Technical Service Bulletin

40 Front stabilizer bar is noisy

40 13 32 2010330/5 August 16, 2013. Supersedes Technical Service Bulletin Group 40 number 13-31 dated July 19, 2013 for reasons listed below.

Model(s)	Year	VIN Range	Vehicle-Specific Equipment
TT	2004	000001 - 025177	Not Applicable

Figure 1. Front stabilizer bar (1), rubber mount (2) and coupling links (3).

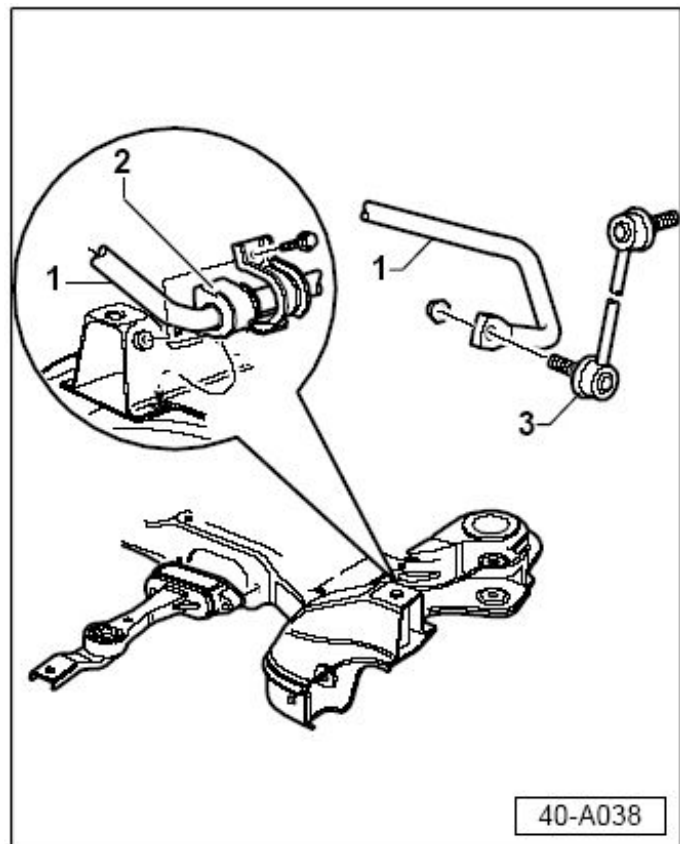
Front stabilizer bar makes noise when the vehicle is driven over bumps.

The noise may be caused by the bushing sleeve separating from the stabilizer bar. The noise is generated when the bar moves up and down.

1. Test drive the vehicle to verify customer concern. The noise may only be present when vehicle is either warm or cold.
2. Visually inspect underbody for damage.
3. Inspect the front stabilizer bar (Figure 1, 1) at rubber mount (Figure 1, 2) for any signs of damage, such as the bushing sleeve separated from stabilizer bar.

1. Disconnect left and right side coupling links (Figure 1, 3) from front stabilizer bar and move stabilizer bar (Figure 1, 1) up and down several times. Observe rubber mount (Figure 1, 2) for any signs of damage, such as the bushing separated from stabilizer bar.
2. If bushing has separated from stabilizer bar, replace stabilizer bar. (Only new version parts are available as replacement parts).

New version of stabilizer bar installed.
